BOULDER CITY, NEVADA
ADDENDUM NO. 1
NEVADA WAY RECONSTRUCTION UTILITY REPLACEMENTS
PROJECT NO. 10-0796-STR(3)
FORMAL BID NO. FB-0651-12

NEVADA WAY RECONSTRUCTION - UTILITY REPLACEMENT

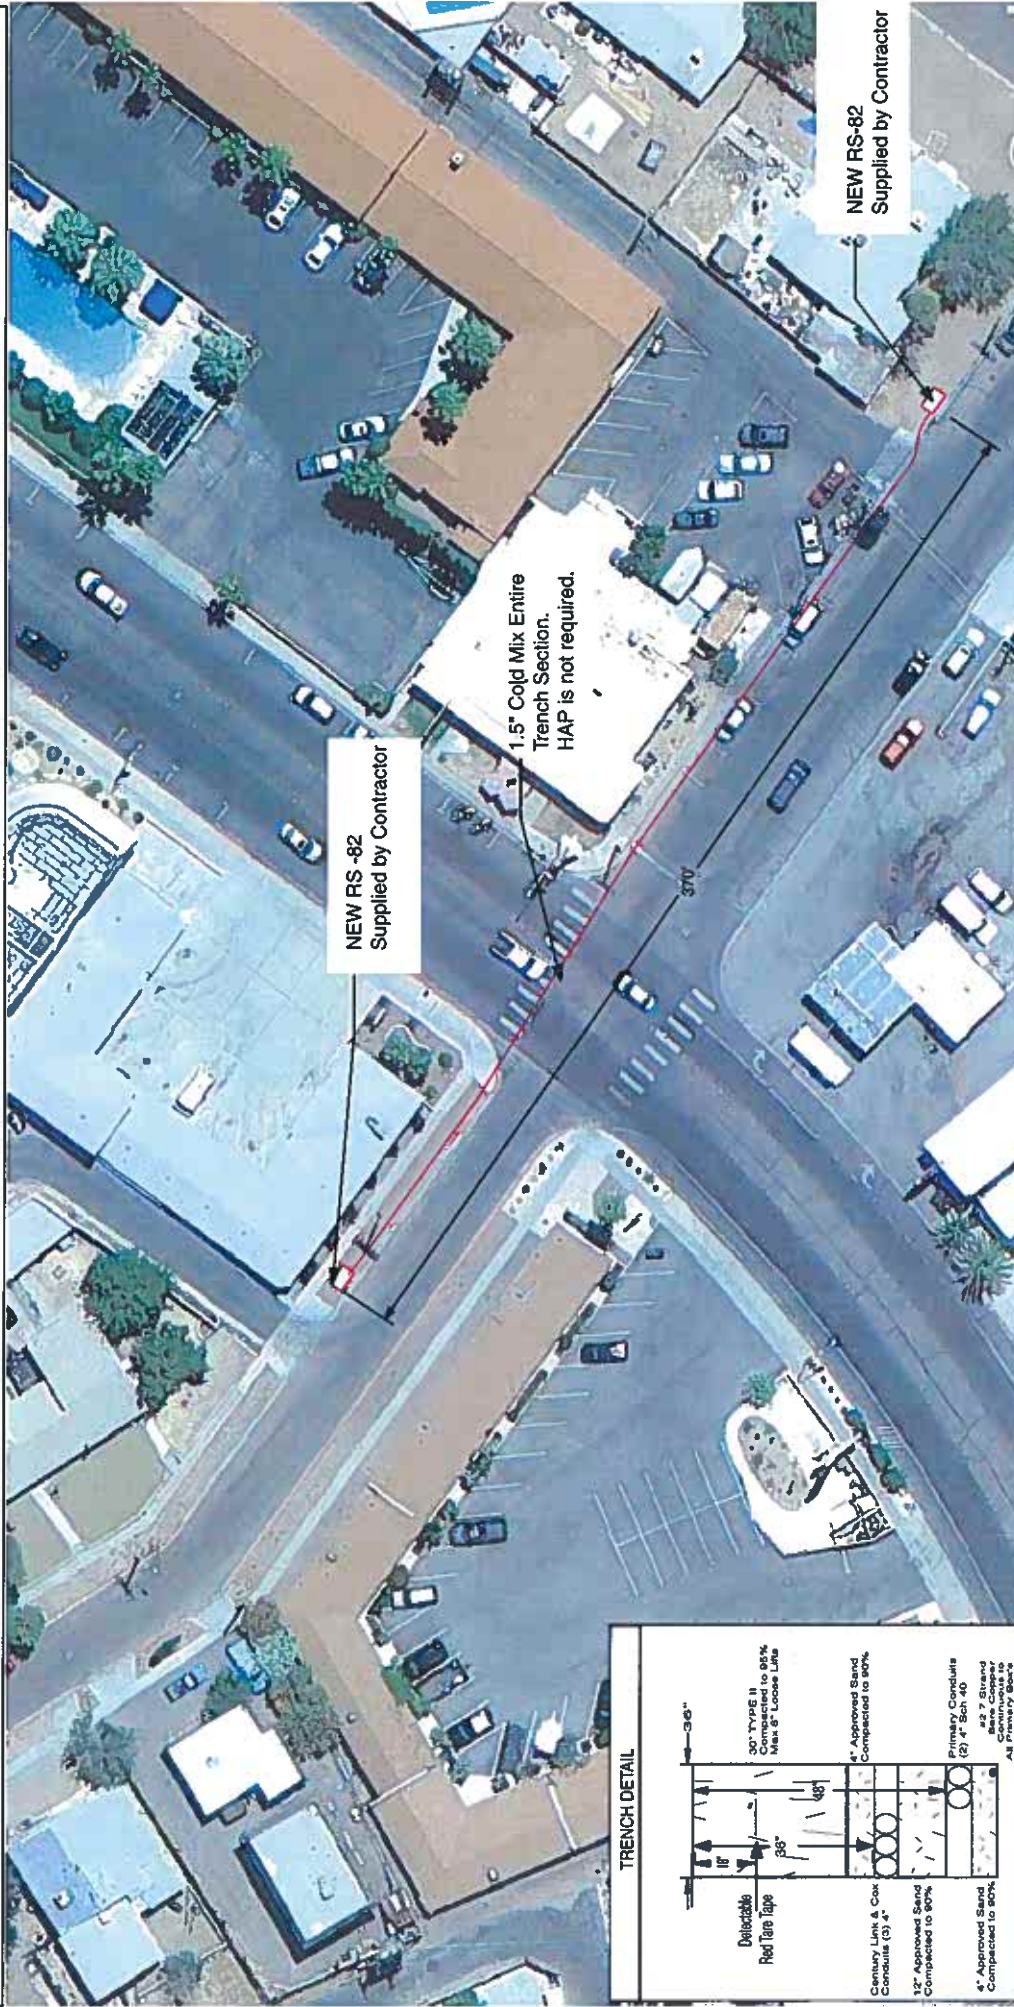
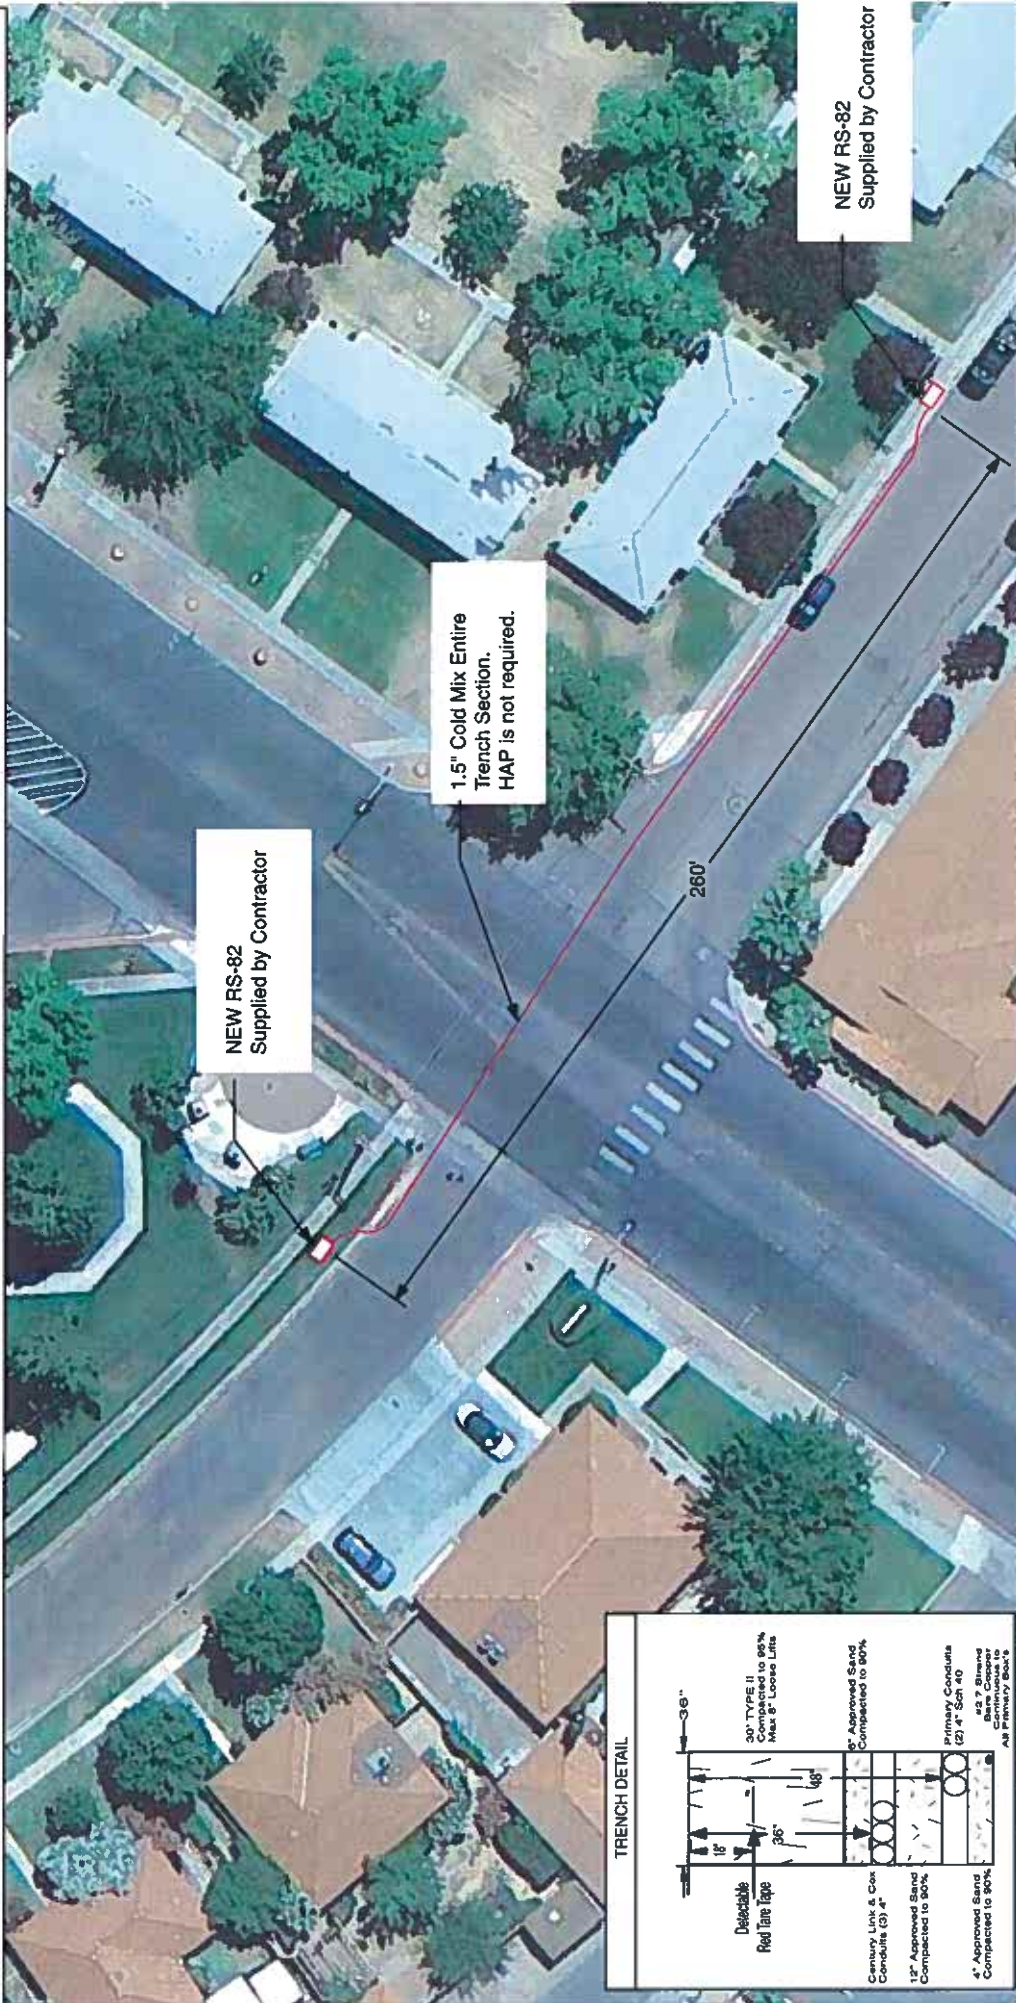
1.5" Cold Mix Entire
Trench Section.
HAP is not required.

1.5" Cold Mix Entire
Trench Section.
HAP is not required.

SKC-1

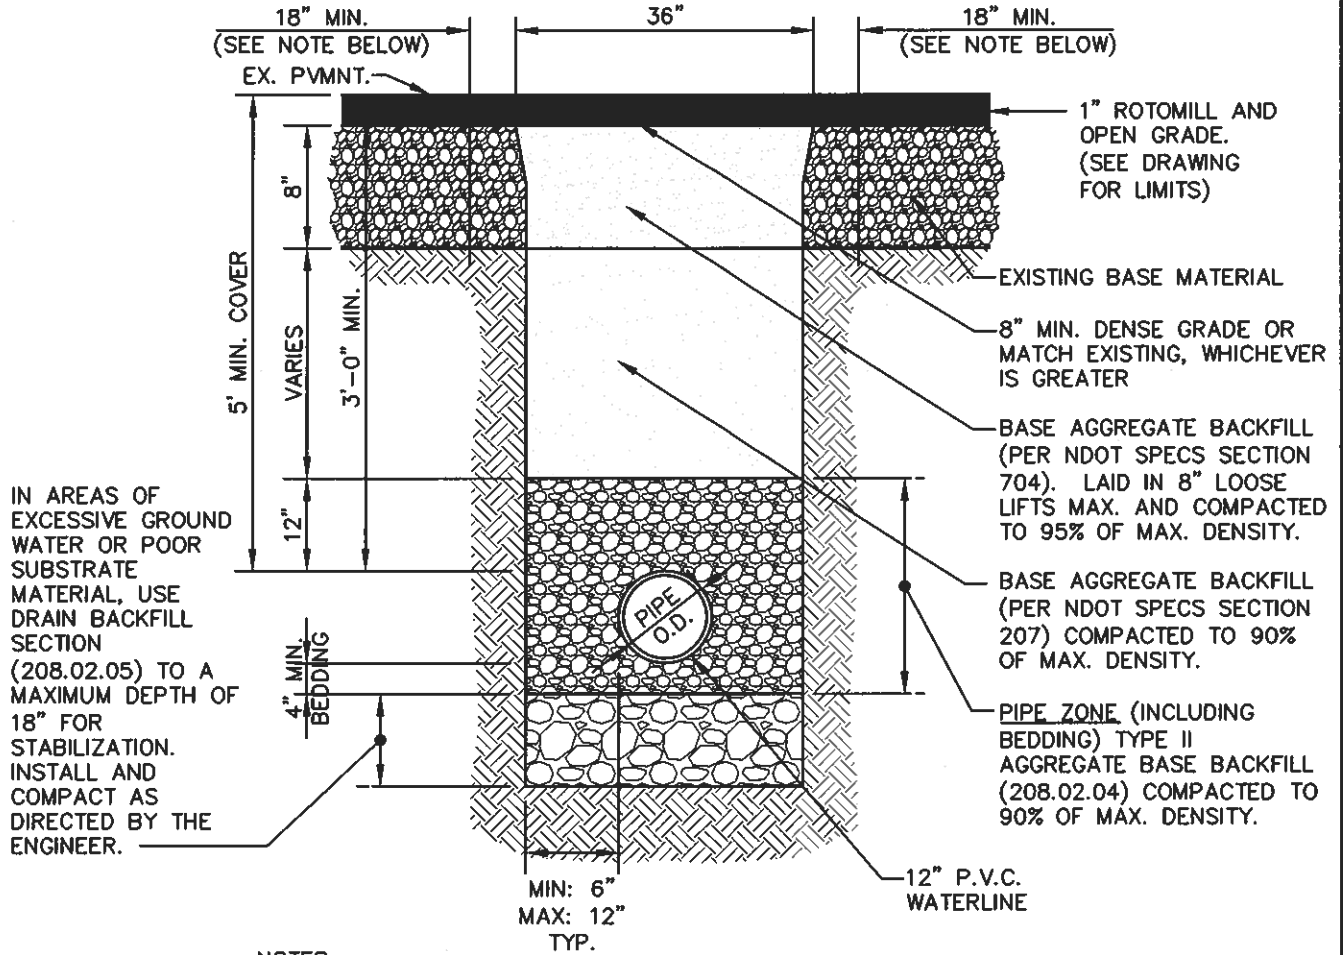
28. Sheet C1.01, remove detail of U.D.A.C.S. Plate No. 18 and replace with attached sketch SKC-1 – Detail A – NDOT PAVED TRENCH DETAIL.
29. Sheet C2.00, revise call out in the plan view for sanitary sewer between SSMH #1 and SSMH #2 to say "158.99 LF 8" PVC SS @ S=0.0082".

1. 1 INCH OPEN GRADE
2. 8 INCH MINIMUM DENSE GRADE OR MATCH EXISTING, WHICHEVER IS GREATER.
3. BASE AGGREGATE (AS PER NDOT SPECIFICATIONS; SECTION 704). A MINIMUM OF 8" TO BE LAID IN A MAXIMUM 8" LOOSE LIFTS. 95% COMPACTION REQUIRED.
4. BACKFILL WITH SELECT MATERIAL TO BOTTOM OF BASE AGGREGATE (AS PER NDOT SPECIFICATIONS; SECTION 207). 90% COMPACTION REQUIRED.
5. FINAL LIMITS OF PAVEMENT REPLACEMENT TO BE DETERMINED BY A NDOT INSPECTOR.

1 REVISED TRENCH DETAIL

SKC-2

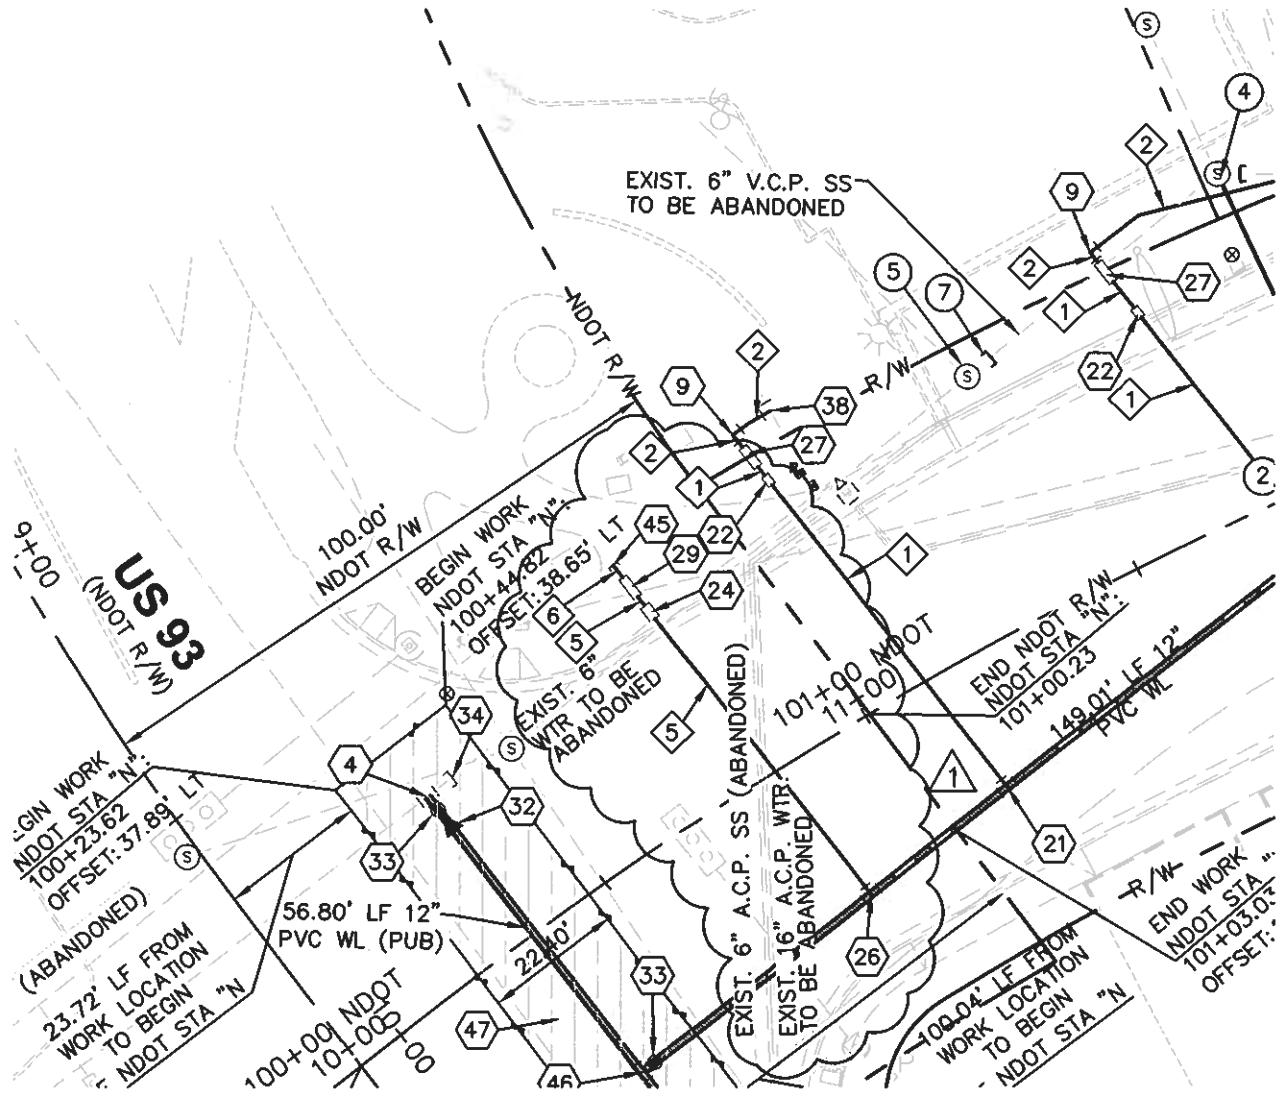
34. Sheet C2.00, in the plan view at SEE SHEET C2.01 FOR CONT. line Water Construction Note 40 is to be removed.
35. Sheet C2.00, in the plan view at approximate station 10+75 add a new 2" service for future irrigation. Refer to the attached Sketch SKC-2.

▲ ADDED 2" WATER SERVICE FOR FUTURE IRRIGATION

SKC-3

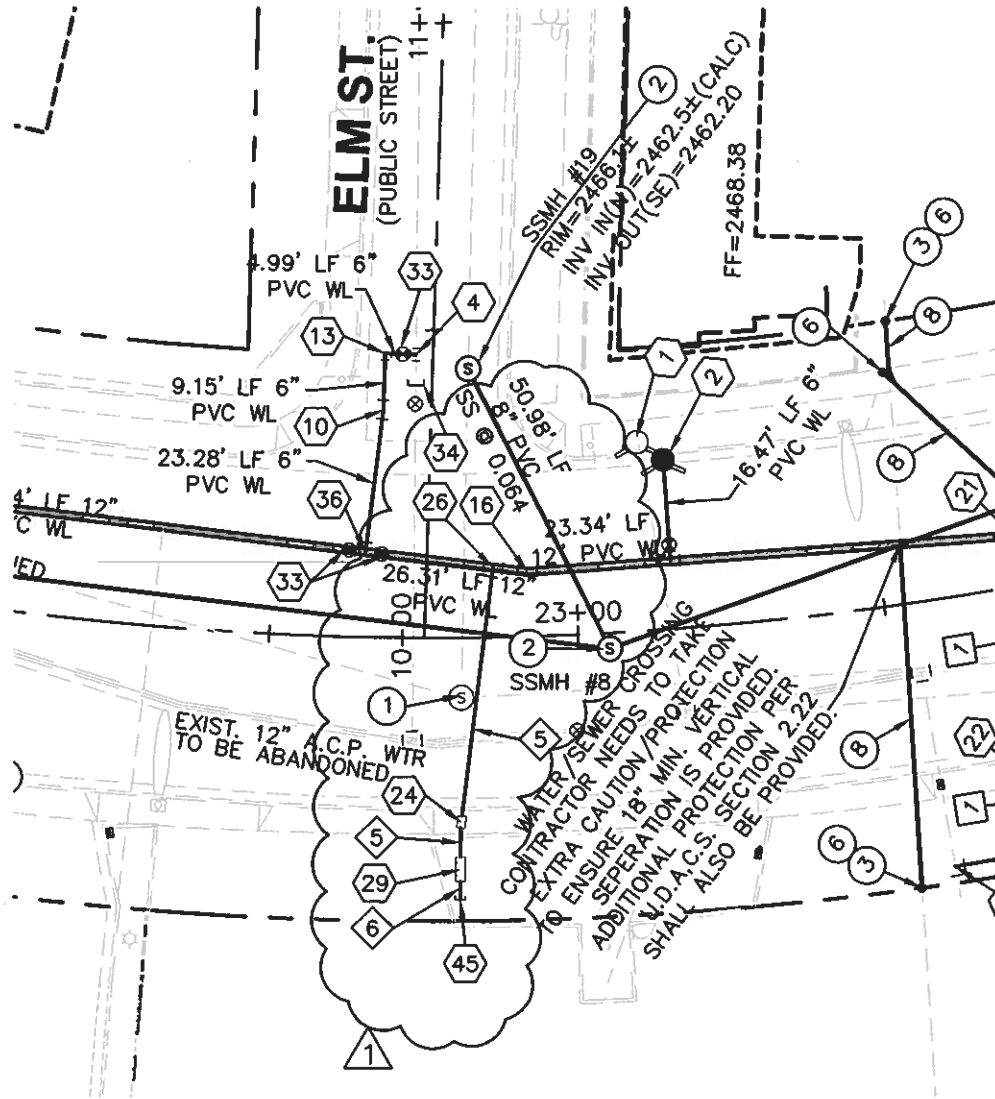
48. Sheet C2.01, in the plan view at approximate station 23+75 on the left side of the centerline Water Construction Note 48 is to be removed.
49. Sheet C2.01, in the plan view at approximate station 22+85 add a new 2" service for future irrigation. Refer to the attached Sketch SKC-3.

△ ADDED 2" WATER SERVICE FOR FUTURE IRRIGATION

SKC-4

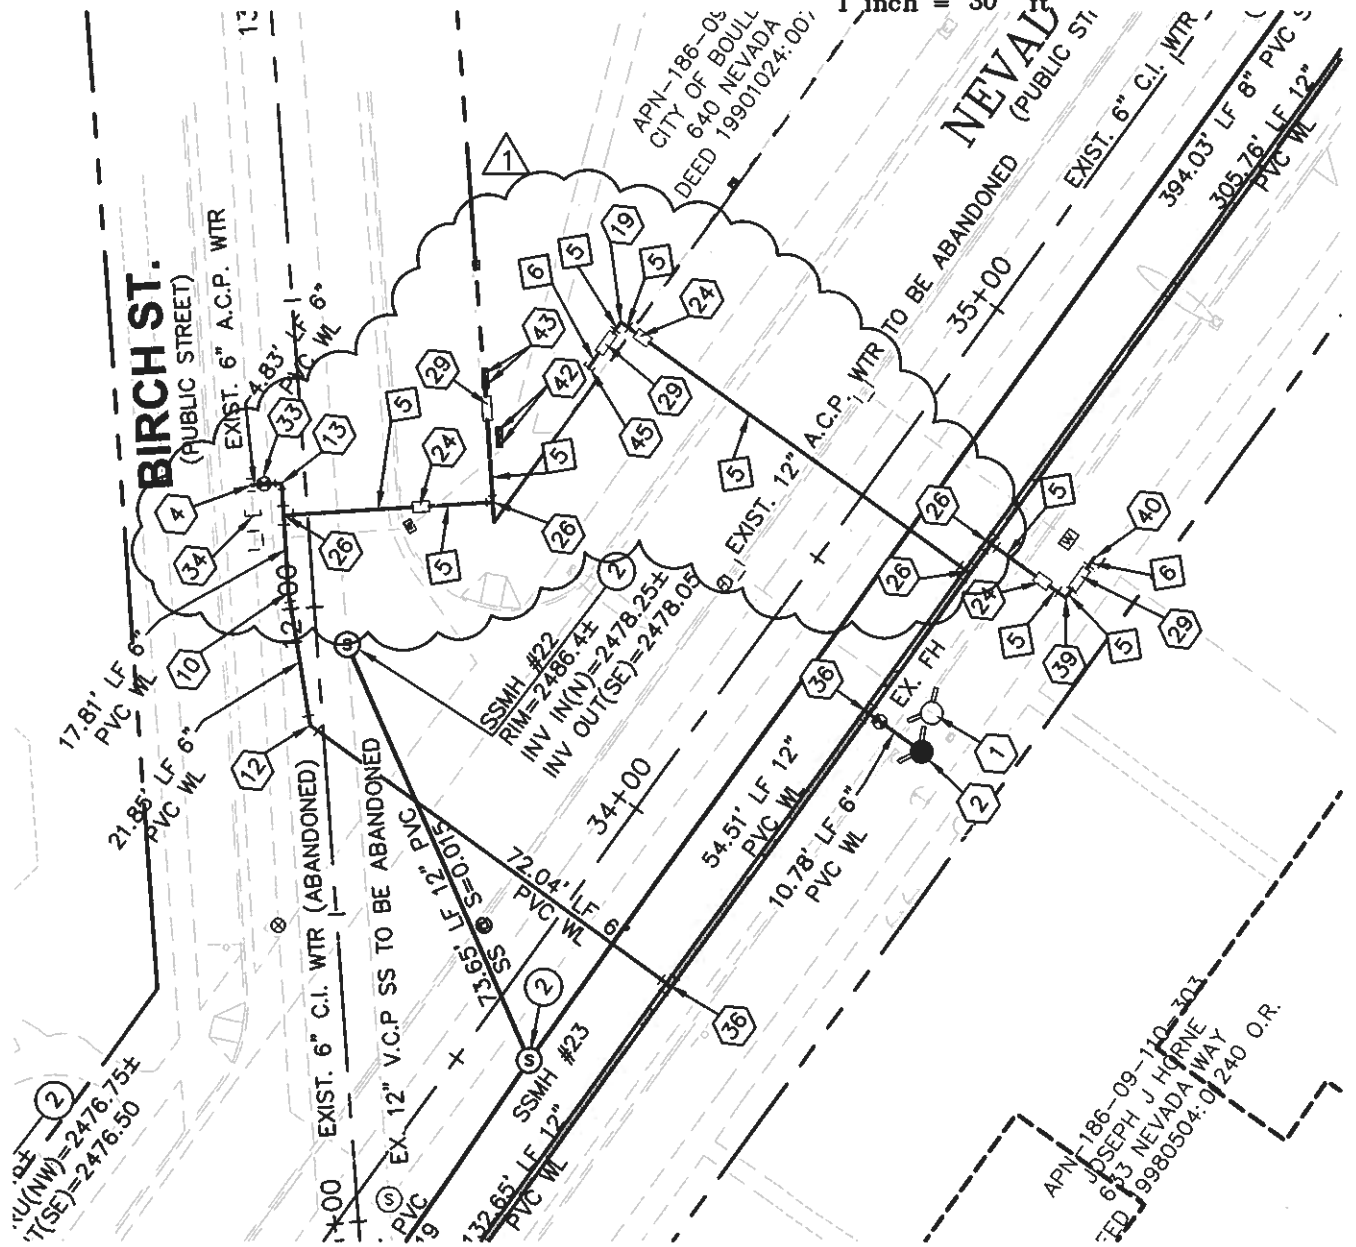
- 58. Sheet C2.03, in the plan view at approximate station 37+75 Add Water Construction Note 3 at the existing fire hydrant.
- 59. Sheet C2.03, in the plan view at approximate station 35+65 add a new 2" service for future irrigation. Also revise the 1" service off of Birch Street to a 2" service. Refer to the attached Sketch SKC-4.

1 ADDED 2" WATER SERVICE FOR FUTURE IRRIGATION. REVISED 1" SERVICE TO 2" SERVICE
